ZEE Systems, Inc.

SERVICE LETTER 47-003-3

- 1.0 EFFECTIVITY: All SZ47-003-(X) Blower Assemblies.
- 2.0 PURPOSE: To provide an alternate kit for the replacement of the Blower Motor in the Blower Assembly.

FIG. 1

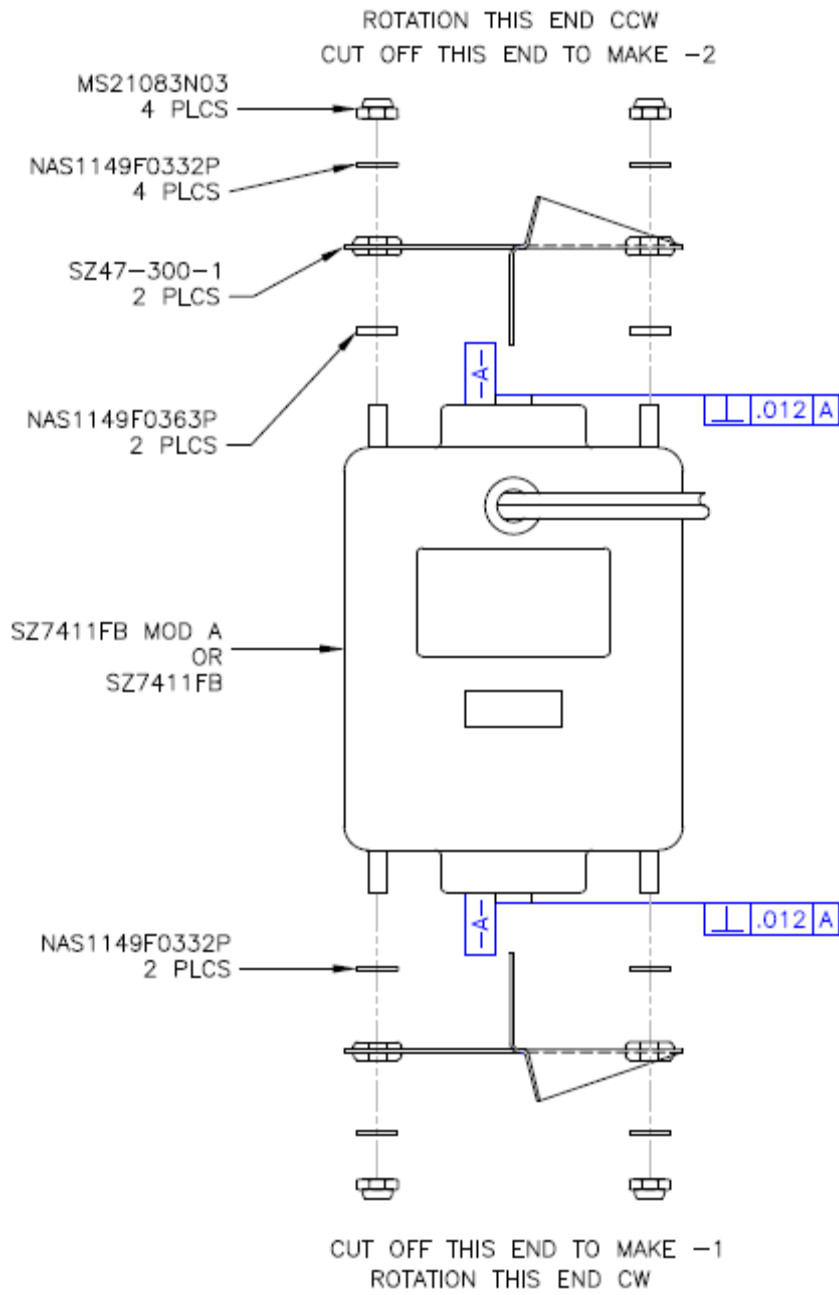
- 9.4 After the opposite shaft has been removed place 1 each Motor Support SZ47-300-1 on each end of the motor. Secure as shown on parts break down, see FIG. 1.

FIG. 2

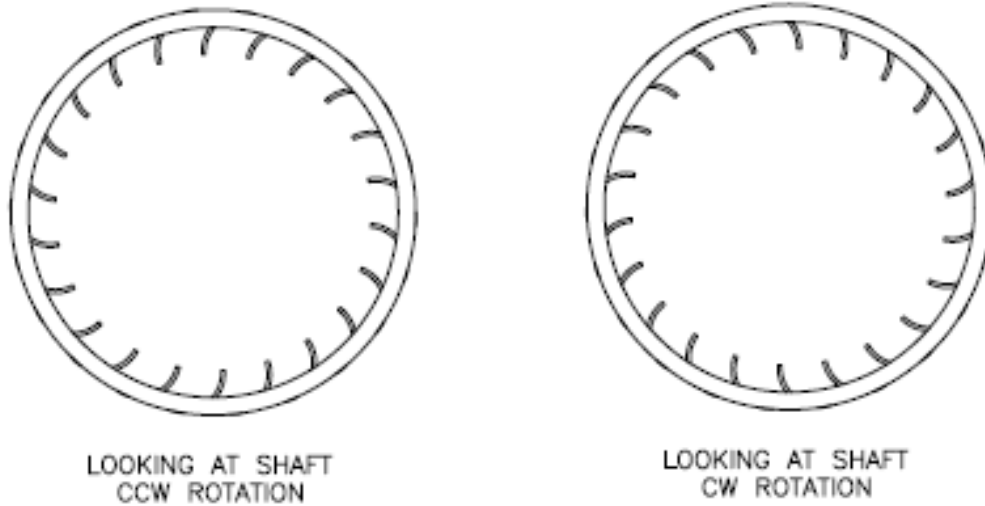
- 9.5 The 16-2527 Blower Wheel rotation must match the rotation of the shaft. See FIG. 2. Push the Blower Wheel onto the shaft until you have the same spacing as the old wheel. Fit the motor and wheel into the Lower Housing (17-2642). Adjust the position of the wheel on the shaft so it does not touch the housing on either side. Adjust the spacing of the wheel on the shaft as necessary. When the proper spacing is achieved attach the 916-901 Clip on the Blower Wheel.
